ADDENDUM NO. 2
May 6, 2025

VII Basis of Design - Electrical Narrative

PROJECT INFORMATION	
Project Name:	Design-Build (DB) Parking Garage Photovoltaic Microgrid System
Project Location:	Columbia Metropolitan Airport - West Columbia, SC
Engineer / Consultant:	Foth Infrastructure and Environment, LLC

COLUMBIA METROPOLITAN AIRPORT (CAE) MAIN TERMINAL PARTIAL ONE LINE DIAGRAM - ALTERNATE PROPOSED PV SYSTEM CONFIGURATION
NO SCALE

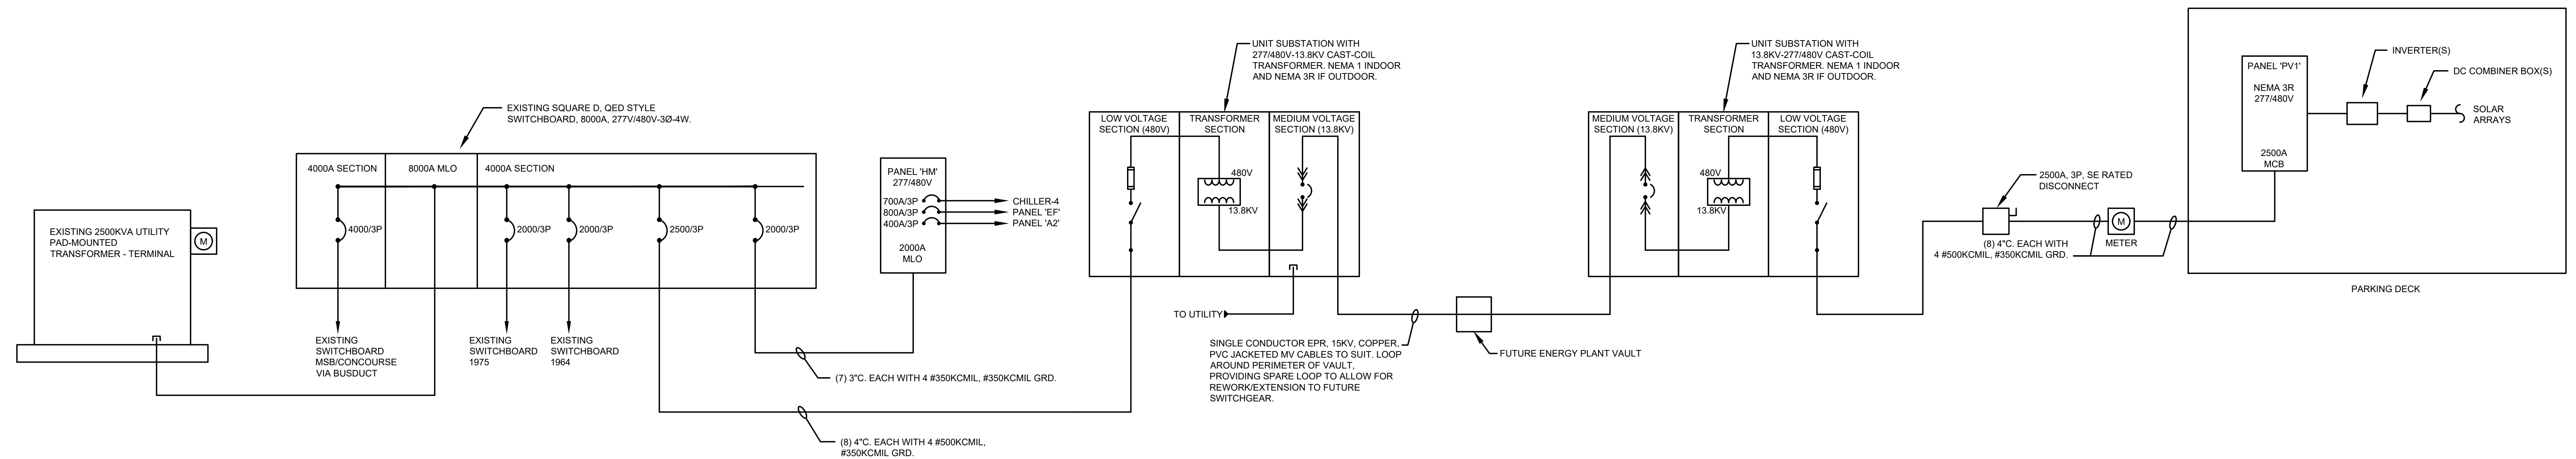
ADD One Line Diagram, T101A, Alternate One-Line Diagram, depicting an alternate medium voltage solution.

PV SYSTEM - ALTERNATE MEDIUM VOLTAGE SOLUTION

1. As an alternative solution to the PV interconnection solution described under the electrical narrative, item D, PV system, a medium voltage PV system interconnection may be utilized to minimize the required conductor sizes and quantities.

2. If this alternative design is utilized, new 13.8kV unit substations may be utilized at the parking garage and at the terminal side of the airport facility to tie the new PV System to the existing terminal electrical system.

3. The 480V, 2500A, PV distribution cabinet/switchboard located at the parking deck will be interconnected to the low voltage side of the parking garage unit substation. This unit substation will step-up the voltage from 480V to 13.8kV. This substation would then, via 15kV medium voltage cables, connect to a unit substation located near the existing terminal service, which would step the voltage down from 13.8kV to 277/480V for connection to the existing 8000A switchboard.

4. The interconnection feeder between each unit substation transformer/switchboard shall consist of a 6" duct and EPR 15kV medium voltage cable with PVC sheathing. Interconnecting feeder size shall be based on final routing/conductor length – voltage drop shall not exceed 3%.
